## **LAVERSTOCK & FORD PARISH COUNCIL**

### **Report for Agenda Item 21.024**

**Subject:** Local Plan Consultation Joint Responses  
**Date:** 12<sup>th</sup> February 2021  
**Author:** Trudi Deane, Deputy Clerk.

#### Salisbury: where development might take place - Site 1 North East of Old Sarum

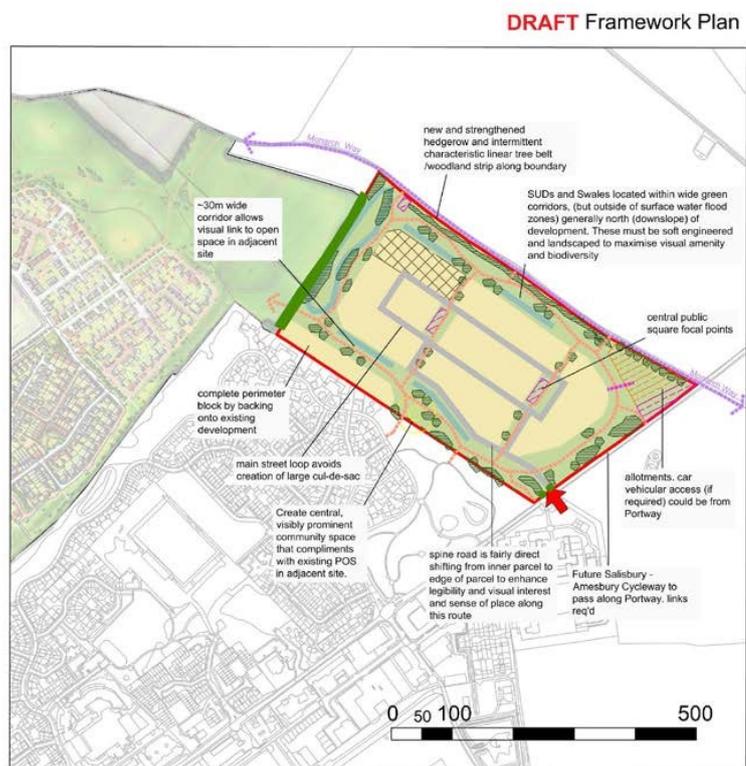
Site 1 lies at the very northern edge of our parish and the greater Salisbury area. It lies just over a slight ridge as you approach Old Sarum along the Portway from the north east. At the moment Old Sarum is hidden by the ridge so the approach along the Portway by car is in a rural setting until the ridge is crossed. The transition into the built environment is then currently softened by the country park with its recently planted trees, which lies in front of the existing housing to the right and there is Throgmorton Hall with its surrounding mature trees to the left. If Site 1 is built on it appears likely to be seen over the ridge on the approach along the Portway. The height and positioning of houses and any screening planting will need to be carefully planned and modelled to ensure that the approach views are not spoiled. Similarly, care will need to be taken with the first view of the built environment to maintain the current soft transition, by providing a green buffer between the road and the housing, as described above. A further concern is that the Monarch's Way long distance national footpath runs on the ridge along the north east boundary of the site. This is also identified as a key green corridor in the Green Blue Infrastructure mapping on p23 of the Planning for Salisbury Local Plan paper. The adjoining Longhedge Village to the north west has a country park in the equivalent field to Site 1 separating the housing from the Monarch's Way and forming part of this green corridor. Development of this site will bring housing much closer to the Monarch's Way and cause a blockage to the green corridor. Great care will be needed to maintain the rural feel of the footpath and avoid significant biodiversity harm (even before providing the 10% net gain requirement). A WW2 pill box is situated on the site adjacent to the Portway. This would need to be preserved, together with its context, in any development.

Finally, parts of this site are visible from Old Sarum scheduled monument and, due to the elevation of the field rising away from the monument the roofs of any houses will be higher than the current roof line. Again, scale of development, roof heights and mitigation will require careful thought and questioning of whether the site can support 275 houses without excessive impact. The concept plans do not appear to adequately address any of these issues.

The concept plans are very simplistic. Much more detail is required to judge the actual landscape visual impact, biodiversity impact, etc., but since they are part of a document setting out the proposed spatial strategy for the next 15 years effort in this direction is probably inappropriate as much can change in that timeframe. What is required is consultation on detailed plans in the year or so before sites are considered for planning permission. Responses at this stage need to help formulate the constraints within which the scheme needs to be developed. These constraints should include, but not be limited to:

- Housing set back from the Portway in a similar way to the current Old Sarum north east boundary
- Reducing housing density and height, preferably to single storey, across the development towards the Monarch's Way
- Adequate green space and planting adjacent to the Monarchs Way to provide visual screening and suitable habitat for its green corridor status.

There is no apparent suggestion of mixed residential/commercial use on site 1. A range of community facilities and opportunity for self build is appropriate. However, there is no indication of the range of facilities which are envisaged.

The layout needs to be guided by a detailed landscaping and ecological study and 3D modelling of the development to enable its impact from various viewpoints to be evaluated **before** it is progressed to the planning application stage.

These are likely to be more heterogeneous in design/appearance than those of a volume builder. This may be positive, provided adequate guidance on and control of design features is in place (the parish would expect to contribute to the guidance). If such guidance is not envisaged, they would be better sited away from the north-eastern perimeter of the housing development, in order to minimise their impact on views of the development.
